SERVICE LETTER

No. 707

Modified Flyball Assembly to Improve RPM Control
-- reference attached Hartzell Service Letter No. 75,
dated November 16, 1973.

SERVICE LETTER NO. 75

A-153(A)-(C) FLYWEIGHT (SEE CHART)
(MATERIAL GROUND FROM
SIDES ON "A" MODIFICATION)

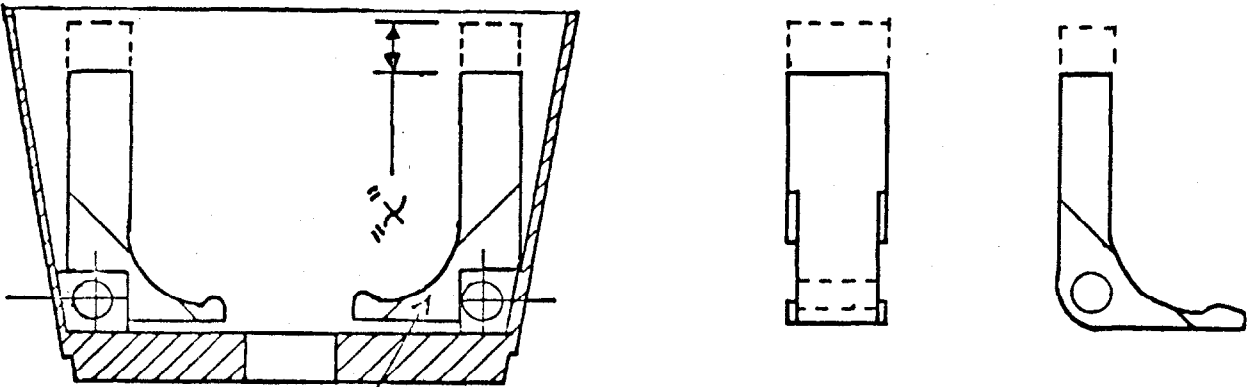
Discussion: To effect an improved RPM control on aircraft with the Hartzell governors, a modified flyweight assembly designed to absorb the torsional motions of the drive gear are being installed in all Hartzell production governors.

- 1) Determine flyweight assembly needed using parts listed in this letter.
- 2) The flyweight assembly can be changed by:
 - a) removing cover assembly
 - b) removing flyweight assembly locking ring
 - c) removing flyweight assembly
 - d) placing new flyweight assembly in place
 - e) replacing lock ring, making sure it is in place
 - f) replacing cover gasket 50672, and
 - g) installing cover assembly

A-153A-2	0	1600-2800
A-153A-1	.250	2500-3700
A-153A	.462	3200-4350
A-153-2	0	1600-2800
A-153-1	.250	2500-3700
A-153	.462	3200-4350
PART NO.	X" LENGTH REMOVED	RPM. RANGE
